PLANNING OBJECTION

Application Number: 2026/62/92047/W
Land off Netherley Drive, Marsden, Huddersfield, HD7 6HL

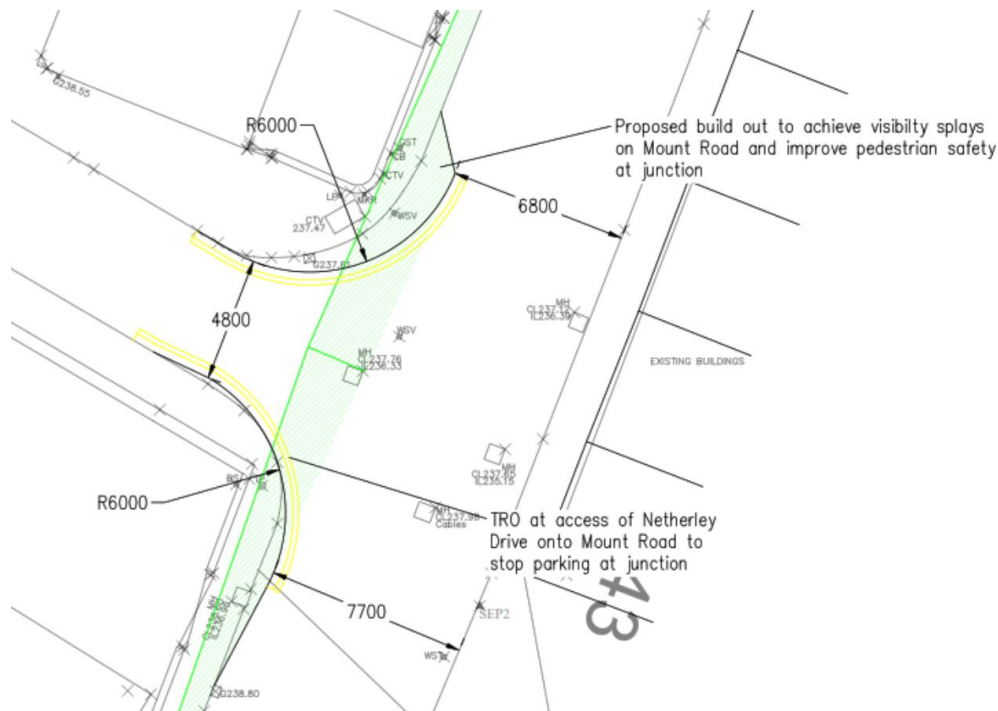
- 6.1 Please see below a marked-up image, which is intended to show the relevant access.
- 6.2 As to the markings, highlighted in [blue](#) is a footpath and public right of way (ref: COL/207/40) (“**PROW**”):

- 6.2.1 This is used by several local properties for vehicular access between their residences and Netherley Drive;
 - 6.2.2 It is also an important route of access for walkers, cyclists and horse riders. The historic footpath provides the principal pedestrian route between: (a) Mount Road and its surrounding areas, including the Pennine Way, Butterley reservoir, Wesseden reservoir, Deer Hill reservoir and beyond; and (b) Old Mount Road and its surrounding areas, including Pule Hill and beyond.

- 6.3 Highlighted in [green](#) is a private lane (“**Private Lane**”). This is used by the 16 properties at 108 Mount Road to 138 Mount Road for vehicular access from their homes onto Netherley Drive (the only access point).

- 6.4 Highlighted in **purple** is a public highway, Netherley Drive. This is used by (a) the 40+ properties on Netherley Drive (which are largely semi-detached houses split into two apartments) for vehicular access between their house and Mount Road; (b) the aforementioned 16 properties on Mount Road for onward vehicular access onto Mount Road; (c) the aforementioned properties mentioned at paragraph 6.2.1, who come off the PROW.
- 6.5 Highlighted in **orange** is another public highway, Mount Road. This is a busy road. As well as being used by all the nearby properties, alongside the A62, it is one of the two key routes between: (a) Huddersfield, Slaithwaite, Outlane, Meltham, Holmfirth and beyond; (b) Saddleworth, Diggle, Delph, Greenfield and beyond.
- 6.6 Lastly, highlighted in **red** is the approximate location of the access road for the development.

- 6.11 The application is for 10 dwellings and 40 car parking spaces. The plans presently only accommodate 2 visitor spaces.
- 6.12 The proposed access from the development will be via the PROW (third party land – outside the applicant's ownership – see images below comparing development with title plan), then Netherley Drive then Mount Road.

Ordnance Survey Map – 1932
Spout Ing

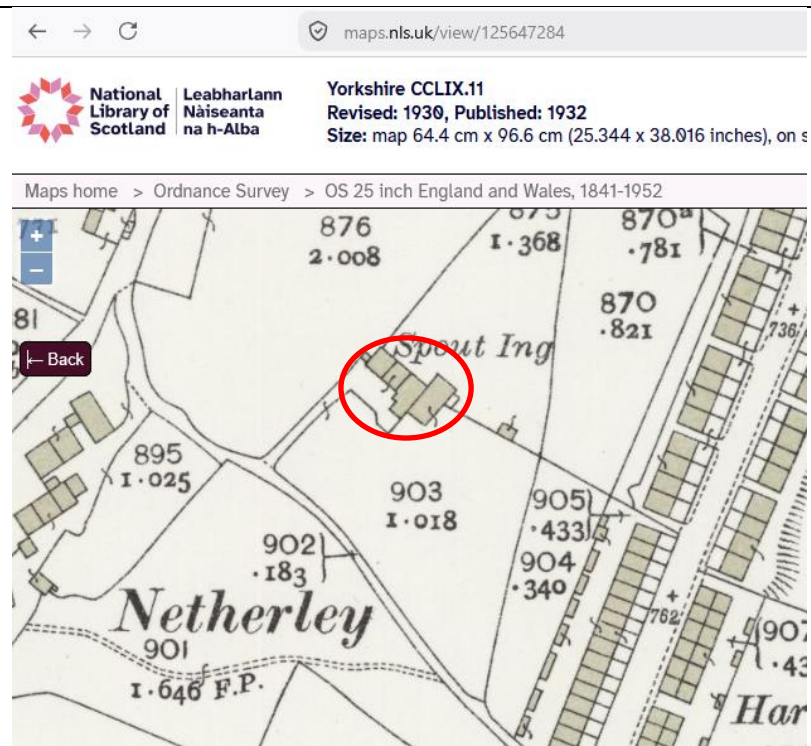
4.3.1 The outbuildings referred to by the applicant as being present as late as 1999 were simply stables as the owner of Pule Springs kept horses (see **Appendix 1** and red-circled area of Google Earth image from 1999). The stables were located at a different location within the site than the historic Spout Ing farm buildings (see **Appendix 1** and red-circled area of Ordnance Survey map from 1932).

Appendix 3 – Parking Images

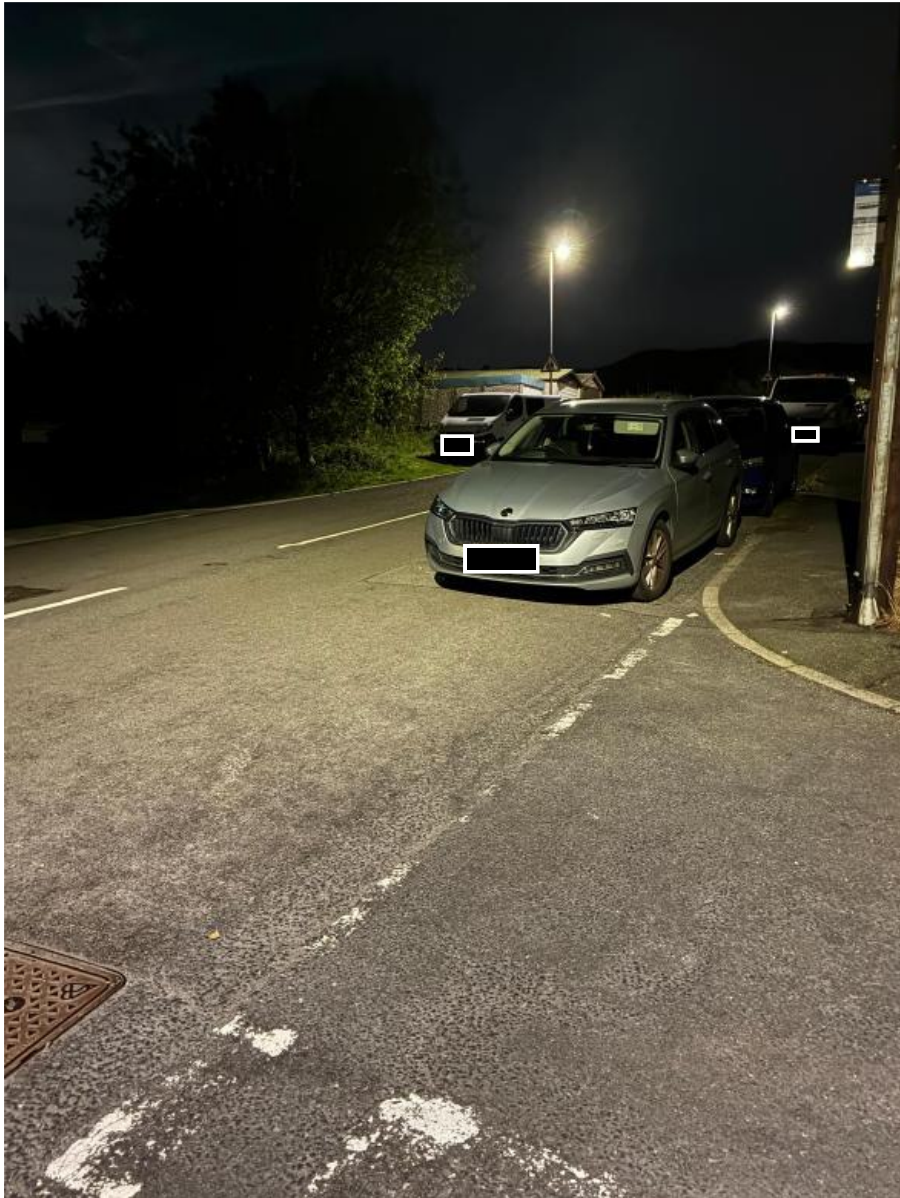
- 6.8.2 There are frequent issues with an inability to exit Mount Road onto Netherley Drive due to: (a) one side of the road being blocked by parked cars (see **Appendix 3**); (b) the other side of the road either having a car waiting at the junction or proceeding towards the junction. As such, vehicles can be stranded on Mount Road in the path of vehicles travelling at speed coming down Mount Road and round the bend past parked cars.
